1st Further Information

**Proposed Temporary Animal Boarding Establishment with Ancillary Facilities
for a Period of 5 Years and Associated Filling of Land in “Agriculture” Zone,
Lot 1756 (Part) in D.D. 118, Tai Tong, Yuen Long, New Territories**

(S.16 Planning Application No. A/YL-TT/665)

Responses-to-Comments

Appendix I – Tree Survey Plan

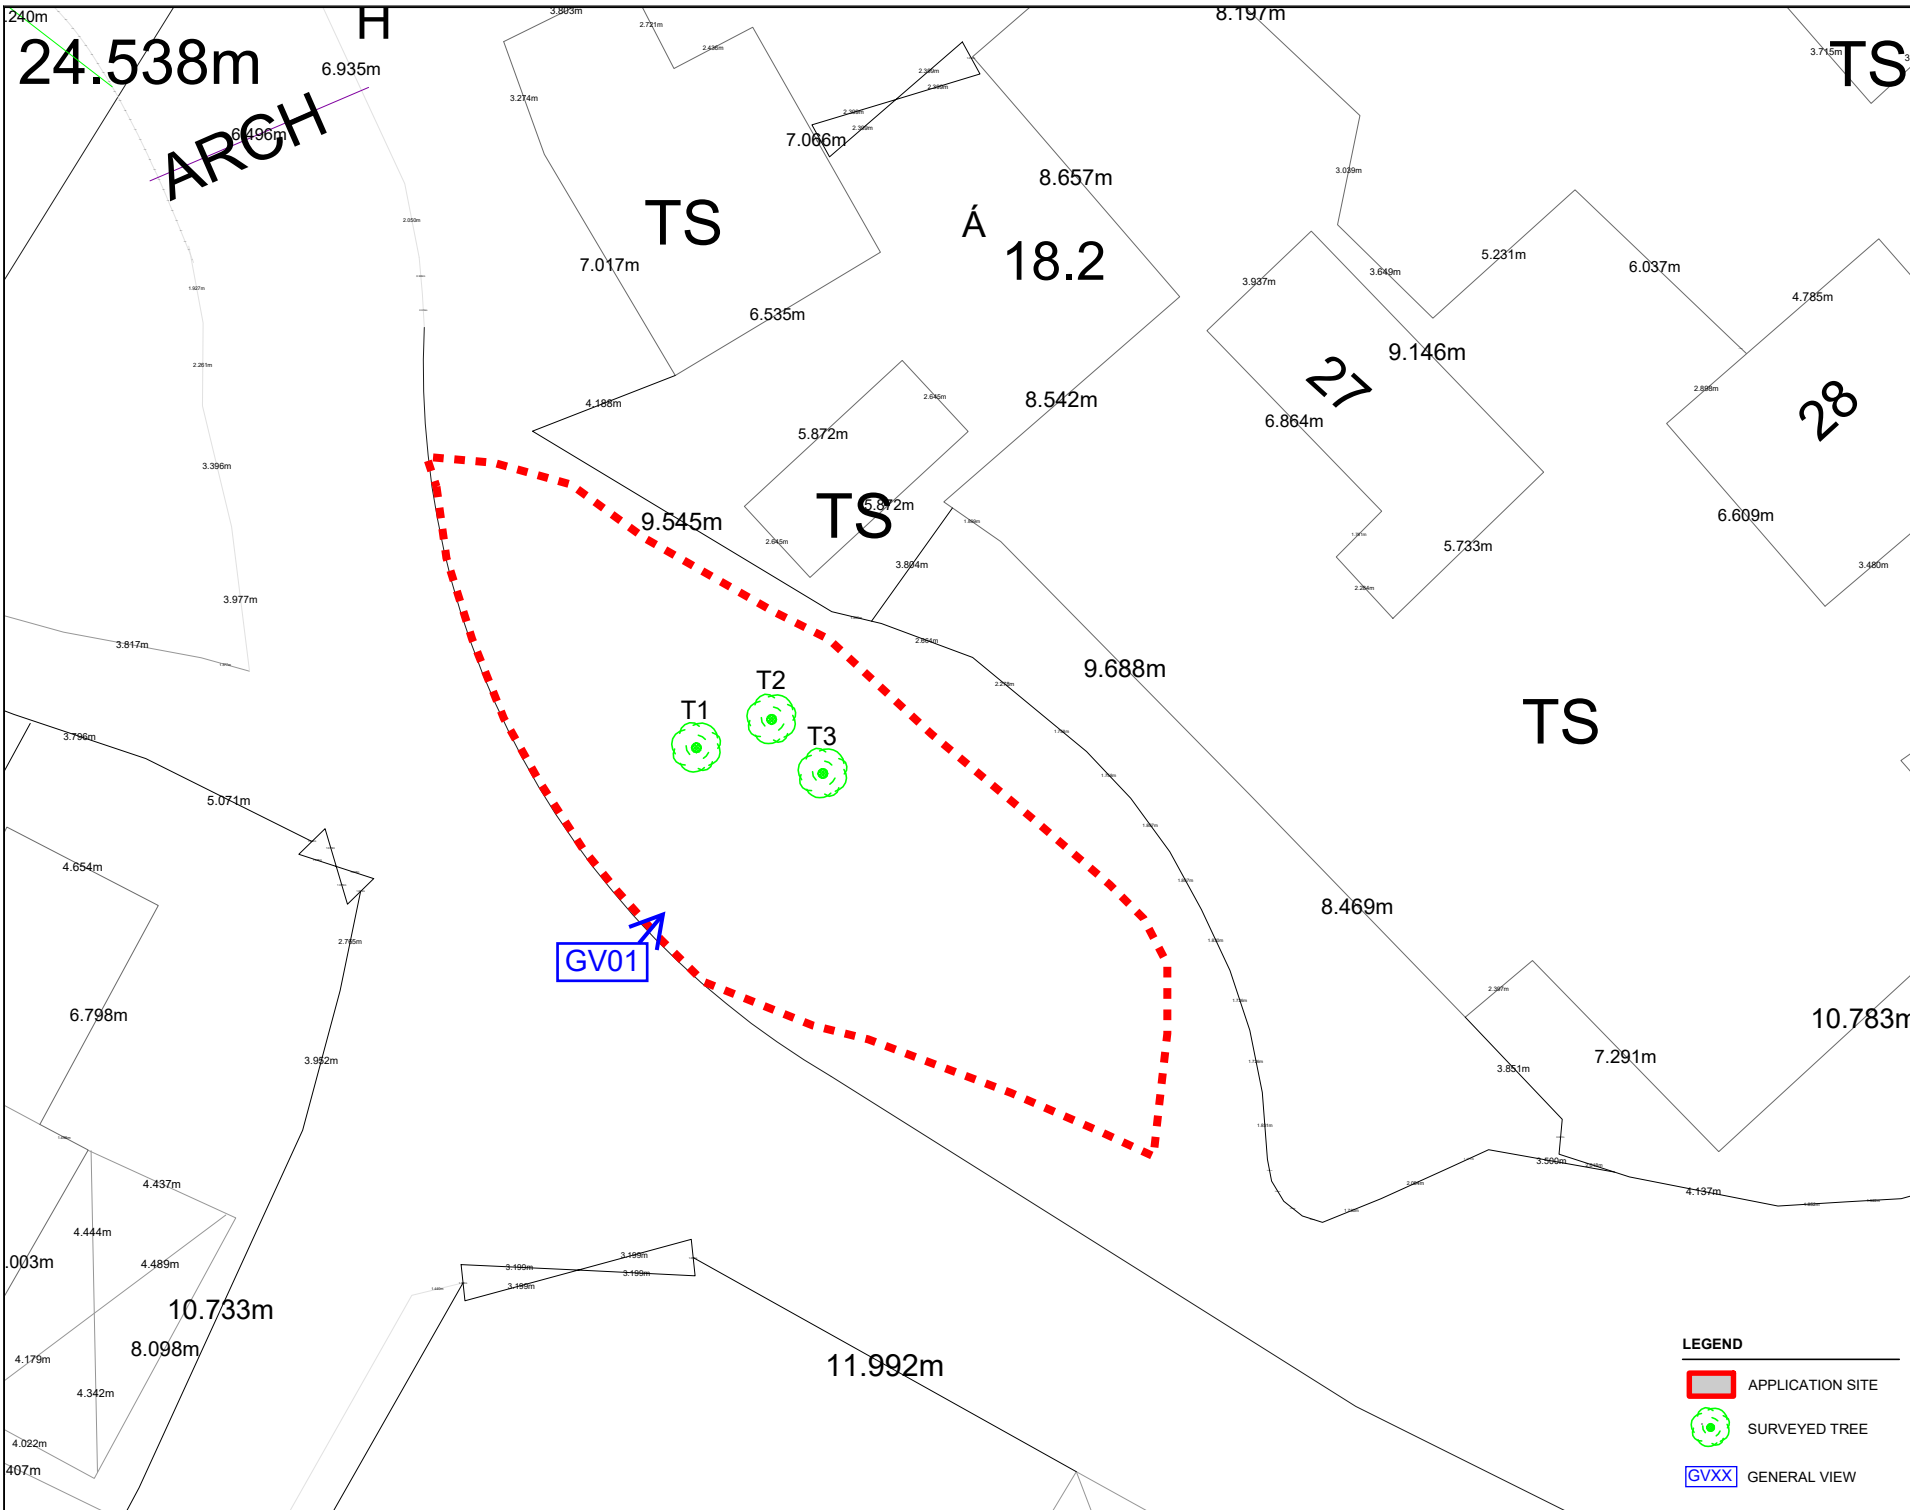
2. Comments of the Chief Town Planner/Urban Design & Landscape Section, Planning Department (CTP/UD&L, PlanD)		
(a)	No mitigation measures and landscape proposal are proposed by the applicant to demonstrate the proposed uses and associated filling of land would not have adverse landscape impact on the existing trees/vegetation within the Site. We would reserve our comment upon receipt of the required landscape technical information.	The site inspection conducted on 13.09.2024 identified 3 nos. of tree within the Site. The tree survey report is enclosed at Annex 1 . The existing trees are of common species i.e. <i>Ficus hispida</i> (對葉榕) which are in direct conflict with the proposed structure. Given their low amenity value and suitability for transplanting, all existing trees are proposed to be felled.

At the time of inspection on 13th September 2024, **3 nos.** tree were found within the Site. **No** dead tree was recorded in the surveyed area. Location of individual tree refers to Appendix I.
